Cranwood - planning application HGY/2022/2775

Approval of details pursuant to condition 19 (Demolition Environmental Management Plan/ Construction Environmental Management Plan) attached to planning permission HGY/2021/2727

Consultation response from the Friends of the Parkland Walk

11.3 Ecological Effects

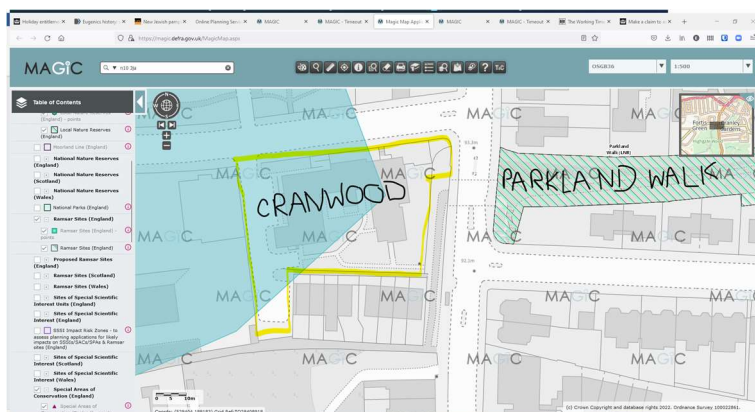
The application was submitted after demolition works had been being carried out on the Cranwood Site for weeks. It effectively tells the Local Planning Authority that no mitigation should be implemented against potential adverse ecological impacts of demolition on the Parkland Walk.

The justification is the quoted guidance which says that where a receptor (ie area with an ecological designation) is located within 350m of a demolition site boundary it should be considered. This is followed by the assertion that in the Cranwood case no such nearby 'receptor' exists.

On that basis, no consideration whatsoever was given to the adverse environmental impact of demolition or construction on the Parkland Walk. The rationale, that allegedly the government's map indicates that there are no ecological designations within 350m of the Cranwood site boundary, is provably incorrect as a matter of fact.

We accessed this DEFRA source. Here is a screengrab of the relevant detail from DEFRA's magic map (highlighted outline of Cranwood site and 'Cranwood' and 'Parkland Walk' labels added by Friends of the Parkland Walk):

This primary source quoted in the application for approval of the DEMP/CEMP clearly marks the location of the designated Statutory Local Nature Reserve known as the Parkland Walk. It abuts the demolition/construction site. This indicates how the consultants that authored application for approval of the DEMP/CEMP appear to be attempting to mislead the Local Planning Authority and railroading this development through without any of the normal statutory safeguarding procedures. First, the condition 19 was breached. No DEMP/CEMP was submitted to the Local Planning Authority until the works had been underway for a long time. Next, and only after questions were being asked about the apparent cavalier approach to the demolition stage of the redevelopment of the Cranwood site, was a DEMP/CEMP application submitted. As Friends of the Parkland Walk's consultation response demonstrates, the DEMP/CEMP in the approval of details application attempts to deliberately mislead the Local Planning Authority.
